COUNCIL ASSESSMENT REPORT

Panel Reference	2018SNH019
DA Number	DA57/2018
LGA	Lane Cove
Proposed Development	Construction of a three storey education facility on an existing school site, construction of a covered outdoor learning area, expansion of existing school hall, alterations to existing classrooms, removal of trees, conversion of two classrooms to a canteen and Outside of School Hours care facility, landscaping and all associated works.
Street Address	30-32 Kingslangley Road, Greenwich
Applicant/Owner	Applicant- TSA Management Owner - Department of Education
Date of DA lodgement	27 March 2018
Number of Submissions	Total 5 unique submissions
Recommendation	That the Applicant's written request to vary the <i>height of buildings</i> development standard be supported. That the application be approved subject to draft conditions
Regional Development Criteria (Schedule 7 of the SEPP (State and Regional Development) 2011	The Development Application is referred to the Sydney North Planning Panel as the development is declared to be regionally significant development pursuant to Schedule 7 of State Environmental planning Policy (State and Regional Development) 2011. The development i

Figure 4: The area marked with a yellow bubble shows the non-compliant ramp to access the centre portion of the school. The blue bubble shows the proposed parking space.

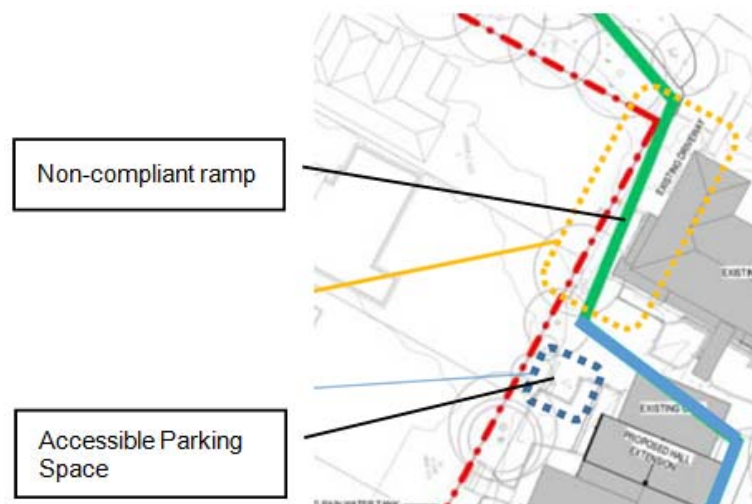
Comment: The current proposal has a section of path that does not comply with the required maximum 1:40 gradient. The non-complying section is located adjacent to the main school building (Building A) and connects the main entry path and car parking area to the centre area of the school. This section of the path also functions as a driveway for maintenance vehicles to travel throughout the school and therefore the applicant has stated that it cannot be converted to an accessible graded ramp that would require a number of switchbacks.

The applicant proposes that accessible access can be provided via an alternative solution. It is proposed that persons with a disability would be able to access the school from the designated disabled parking space located at the top of the maintenance driveway adjacent to the extended school hall. From this parking space the occupant would be able to access the new school building and all other indoor and outdoor areas that would normally be used by the students.

This solution is considered unacceptable given that students with a disability would need to be dropped off / picked up at the designated disabled parking space at the start and finish of the school day. The ramped area appears to be highly trafficked by students and staff throughout the day and would result in a serious safety hazard. The parents or caregivers would be required to drive into the centre of the school to what is an outdoor recreation area before the start of the school day and after the final bell where students are gathering. The alternate solution would also draw unnecessary attention to those students that would be required to use the facility.

Schools have an obligation to provide equitable access for their students, staff and visitors to all facilities from the front entry.

A Deferred Commencement matter requirement has been included in the draft conditions for consideration by the Panel that would require this obstacle to be addressed and satisfactorily resolved by a suitable qualified independent access consultant and in a manner that is equitable.
